## **Addendum #5**

### **Walnut Plaza and Ed Johnson Memorial**

**CONTRACT NO. R-19-007**

SHEET NUMBER:  
**L1.50**

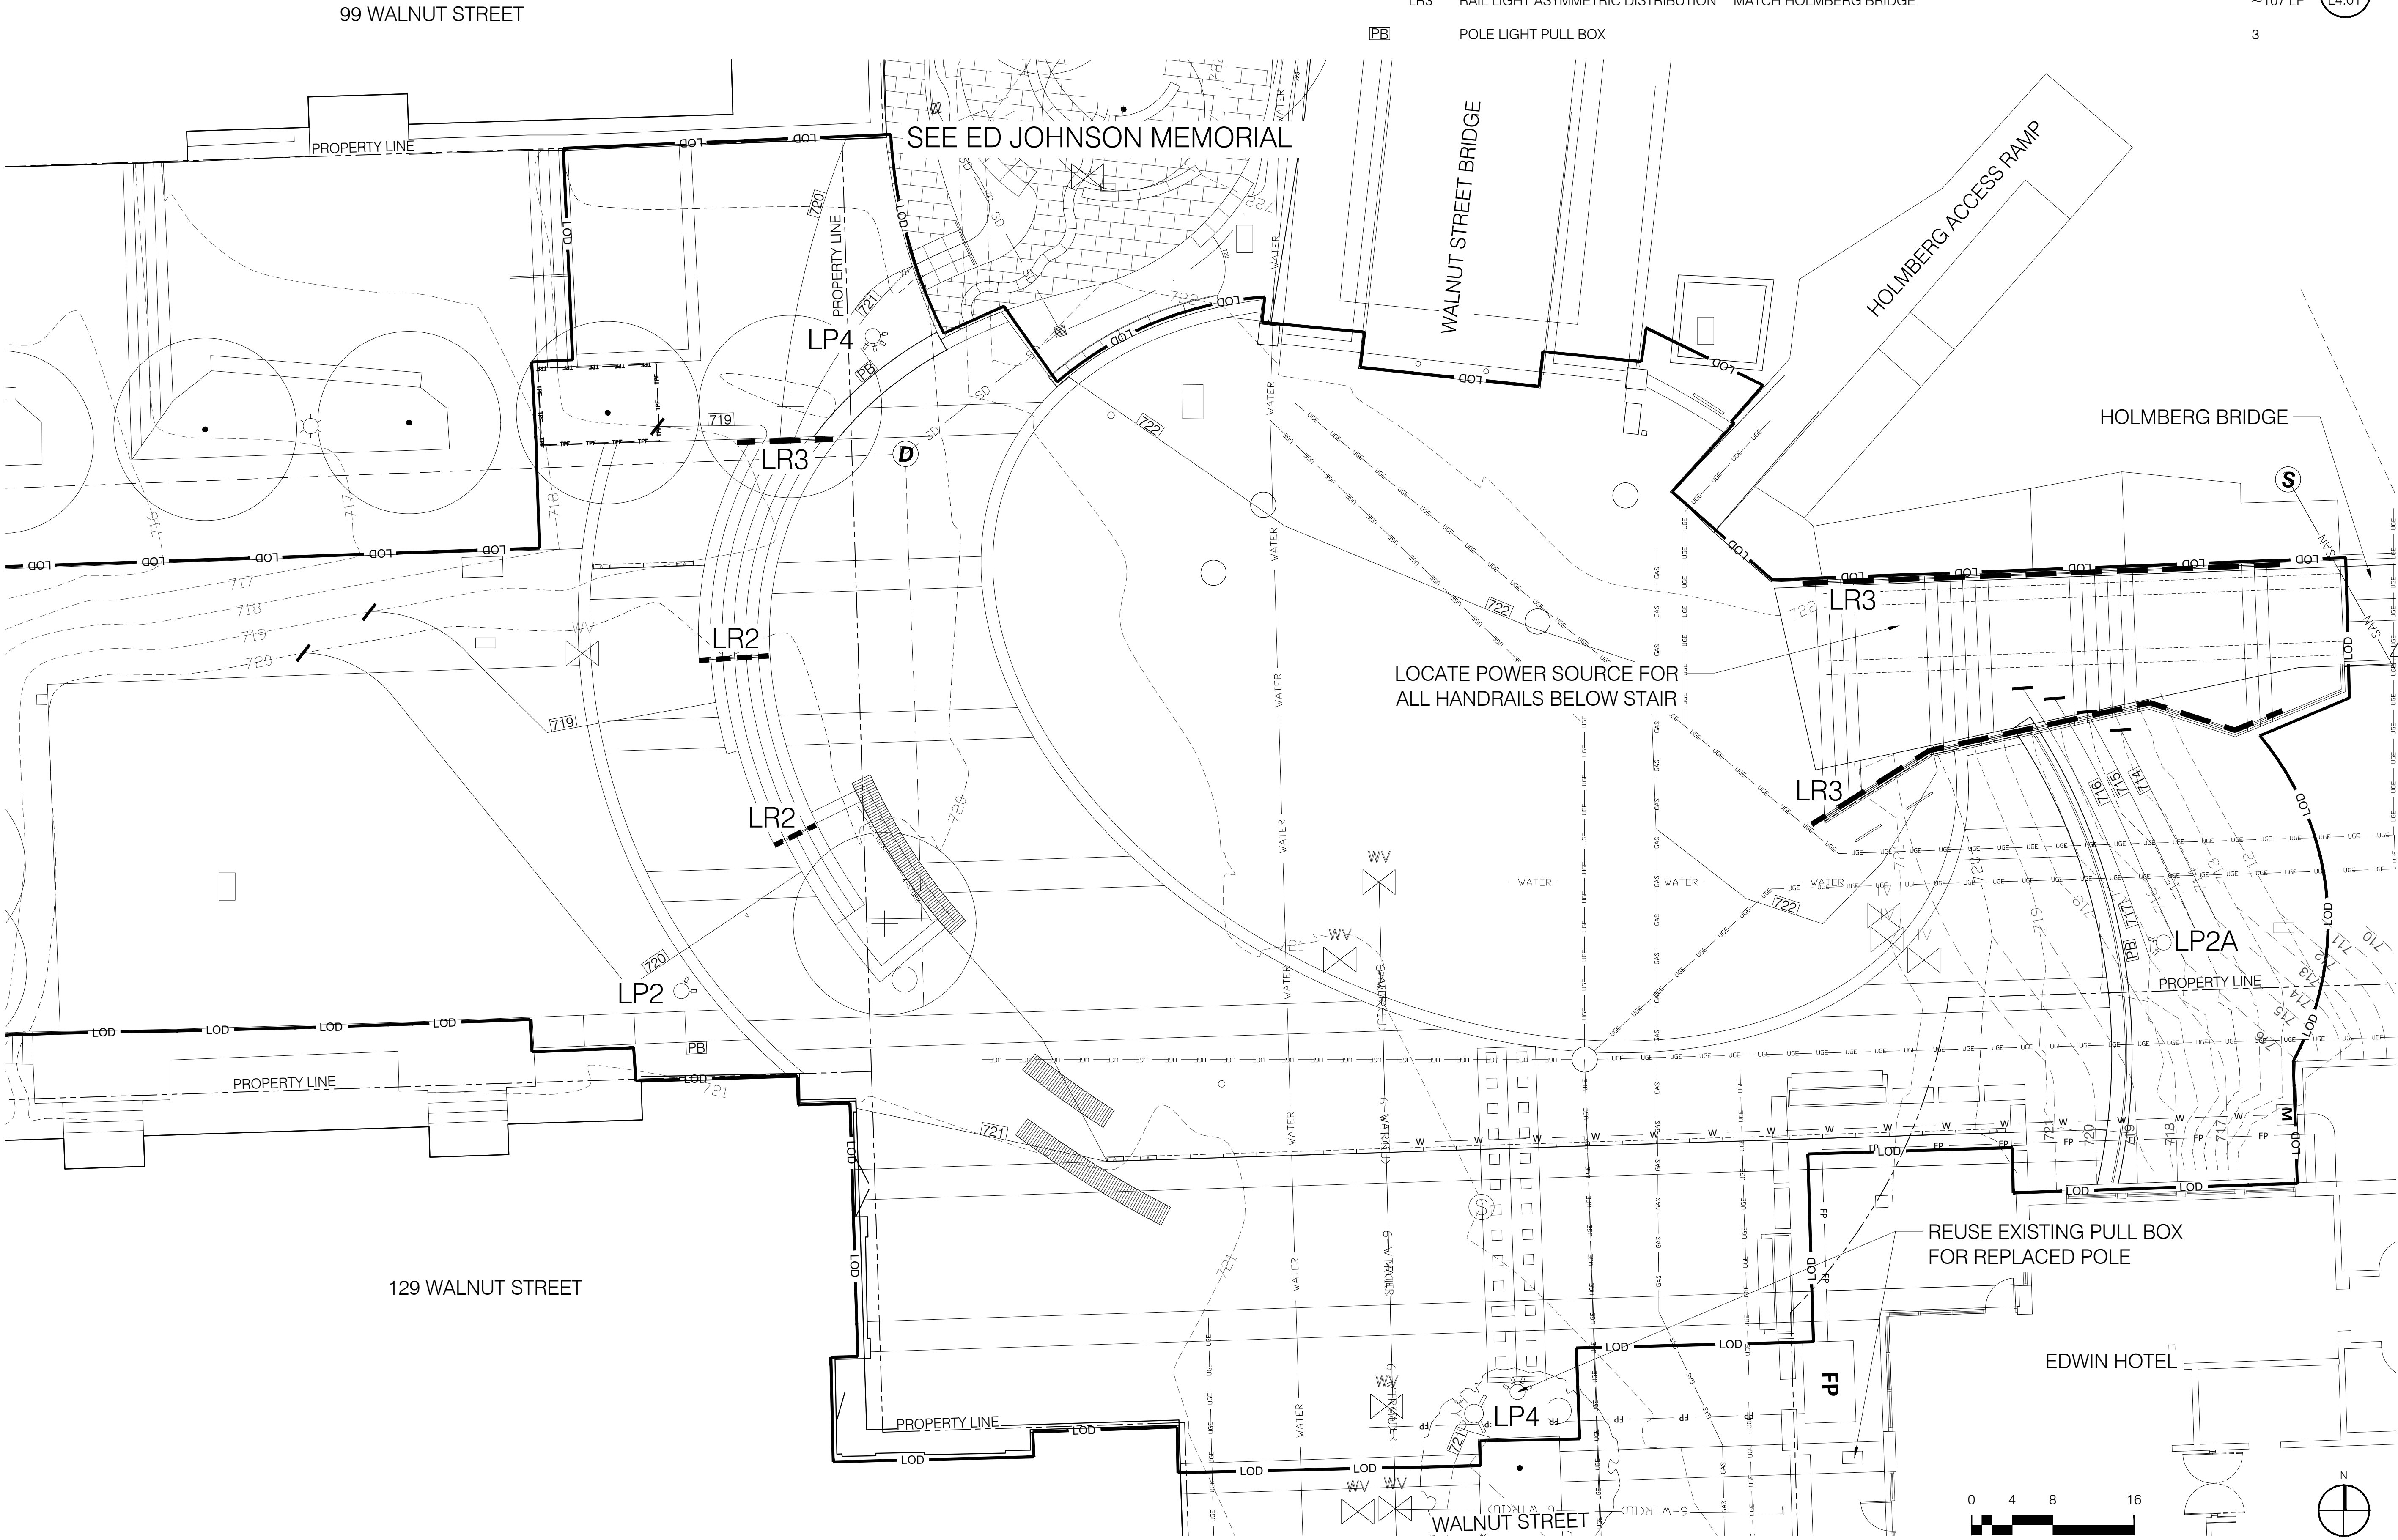
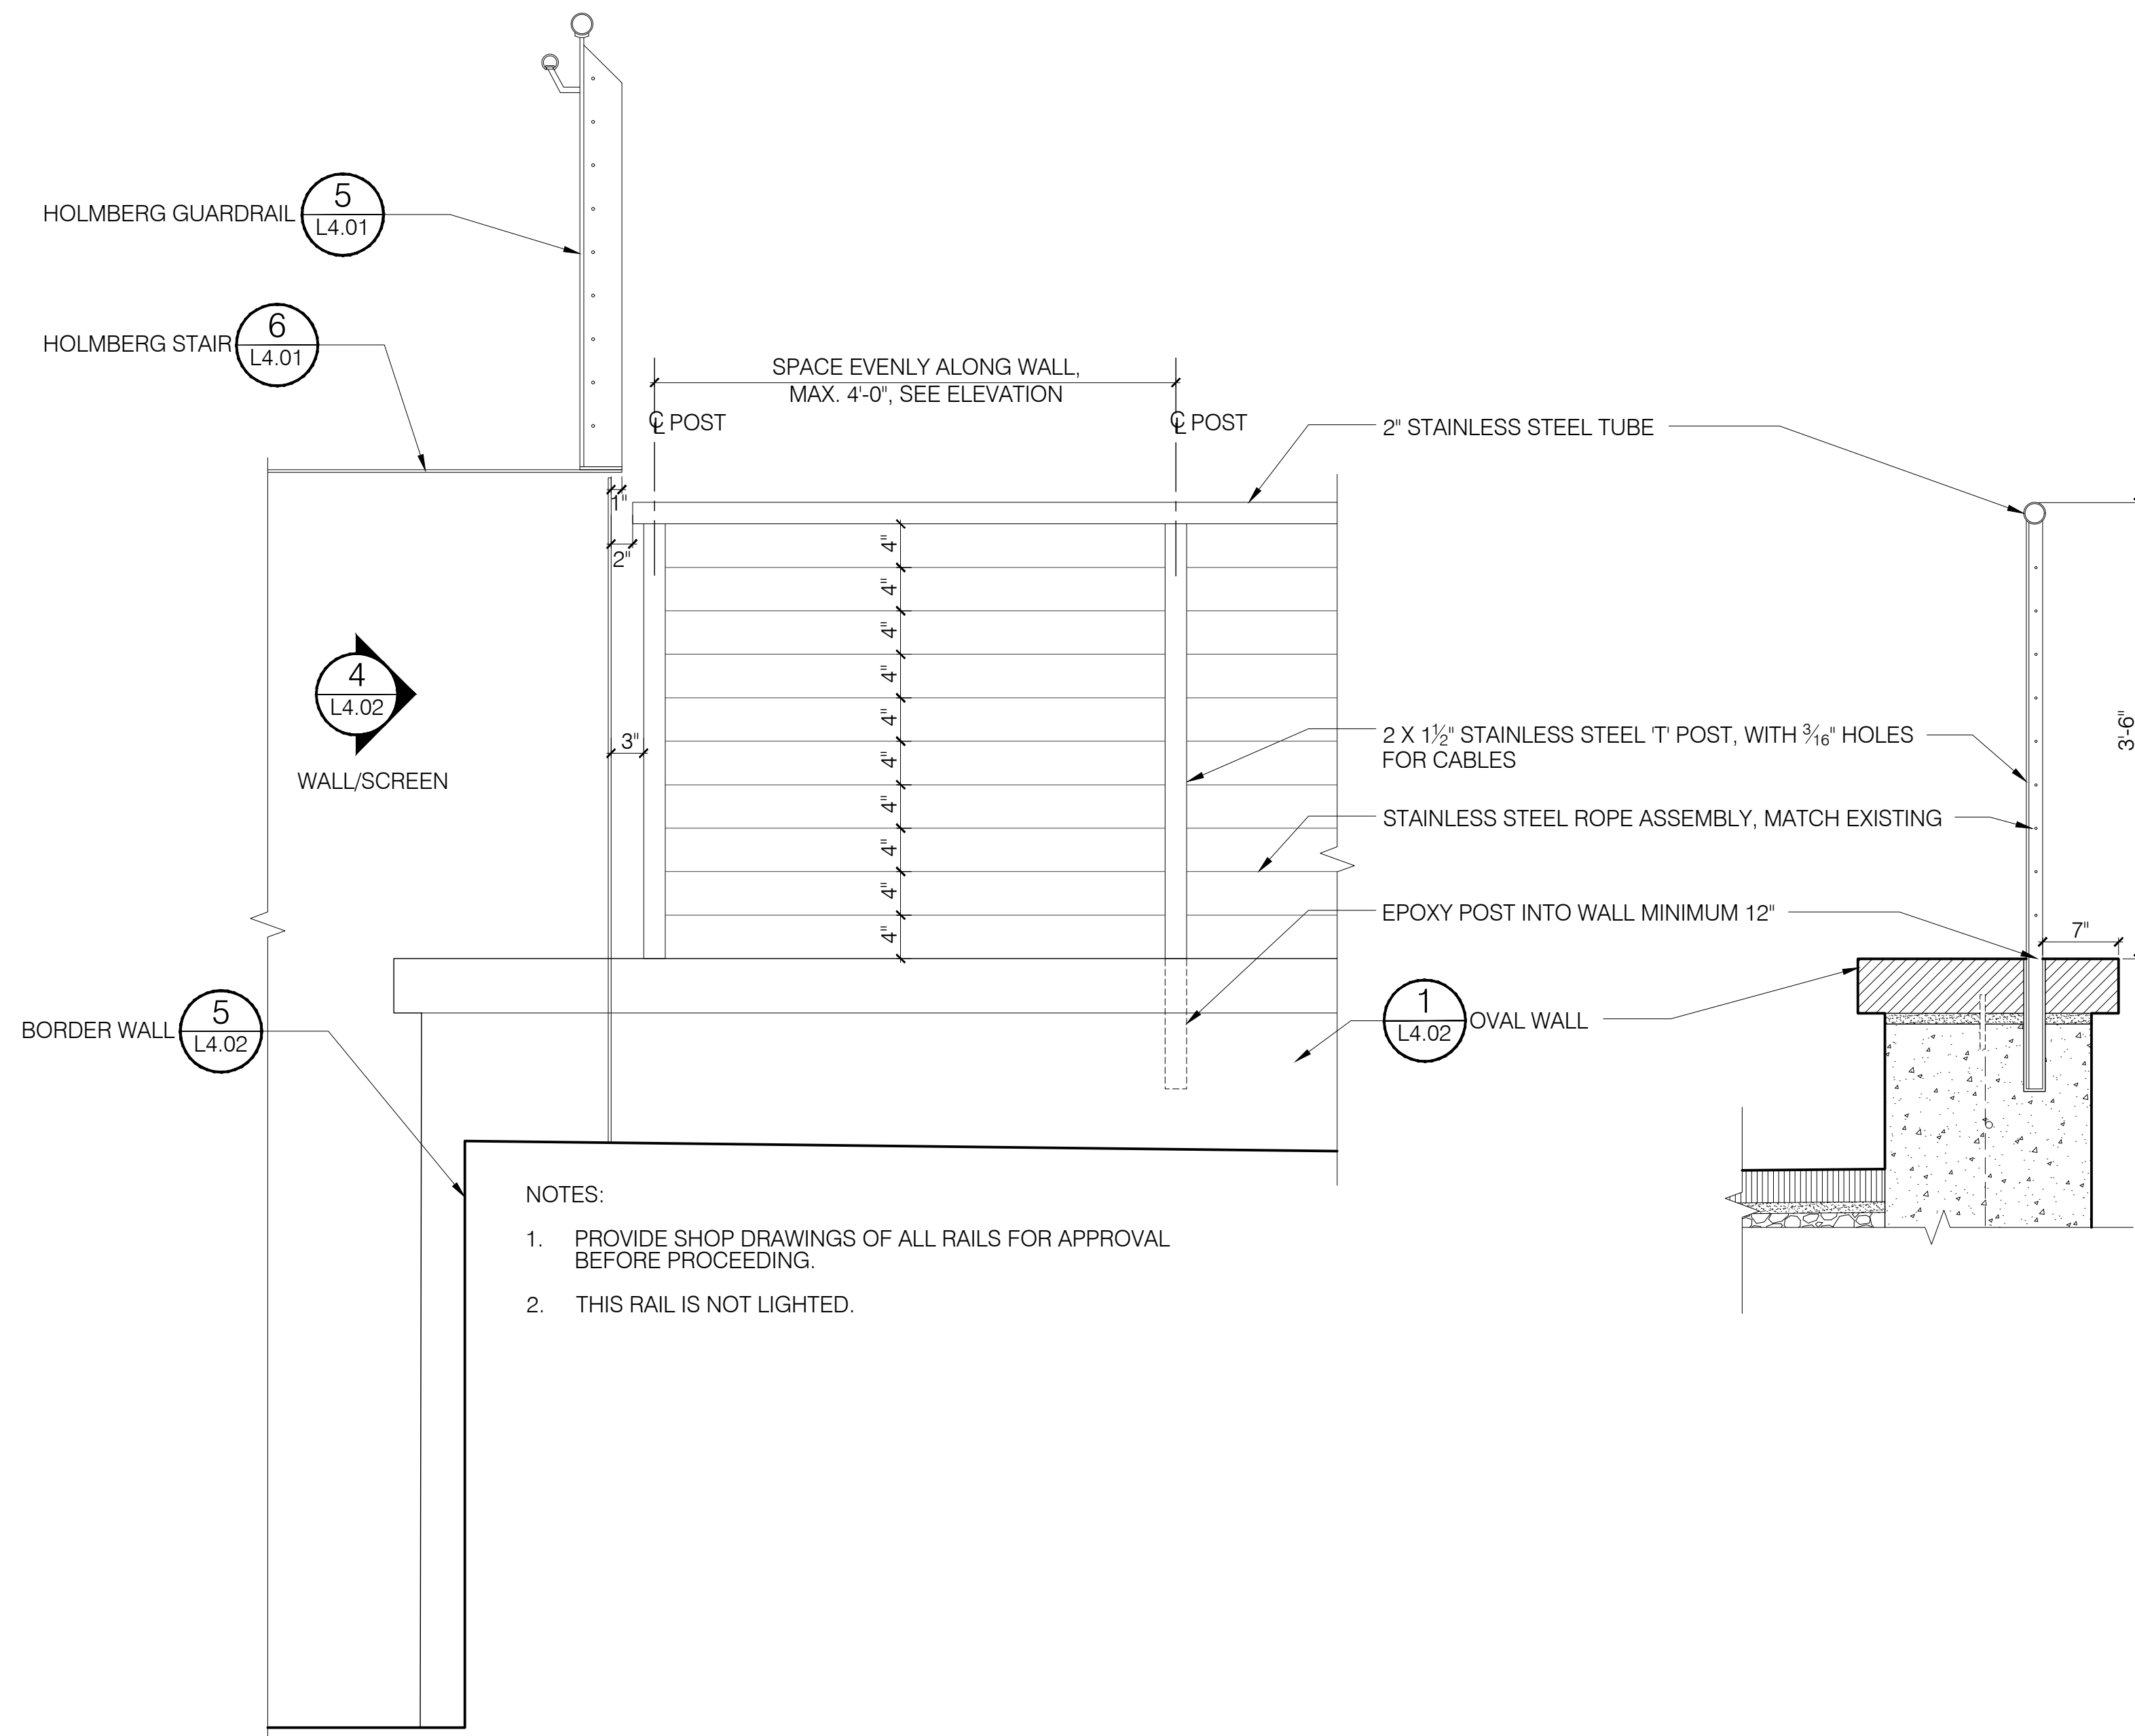
- Sheet L1.50- clarified light pole model number and corrected a reference in the key
- Sheet 4.03- corrected a reference in detail 3

1. On sheet L4.03 there is a base detail for the pole and a detail for couplers to mount the fixtures to the poles, but there is no spec for the overall height of the pole.
  - a. The streetlight layout is shown on L1.50- Lighting Plan. Pole heights are specified in the model numbers found in the key. The light poles can be found at [bega-us.com](http://bega-us.com) .
